Responsible: D. Rutz
Date: 14.12.2006

IGV 645.0 / 645.1 / 645.2 Replacing the circulation pump

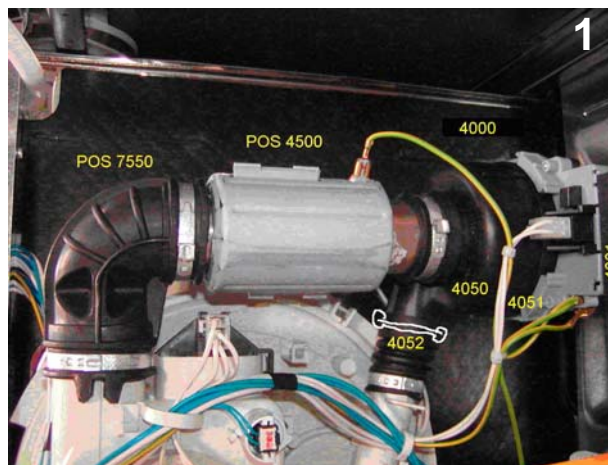
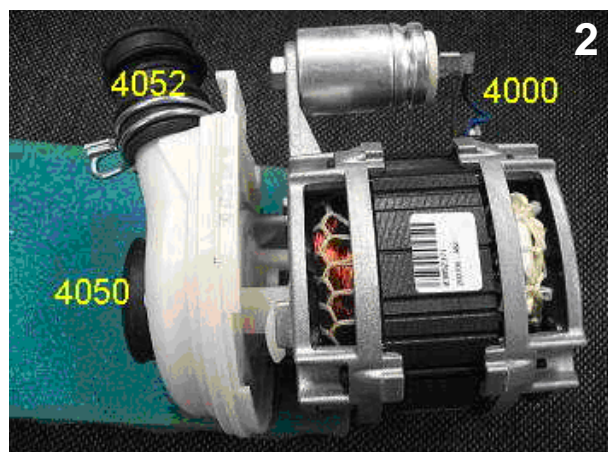
As of production in calendar week 46 2006, the ASCOLL circulation pump (picture 1) and CRIN (picture 2) will be replaced by the MPH circulation pump (picture 3). For appliances in which the MPH circulation pump has been installed as a standard, the 12-digit code will end with a "5", e.g. IGV 645.2 will have the code 845 646 01835.

POS	Spare-part. no.	Designation
4000	43 60 78	MPH 220-230 V EURO kit
4500	43 60 79	Heating element and pump case 220-230 V EURO
4501	43 60 80	Drain kit
4502	43 60 81	Suction bend kit
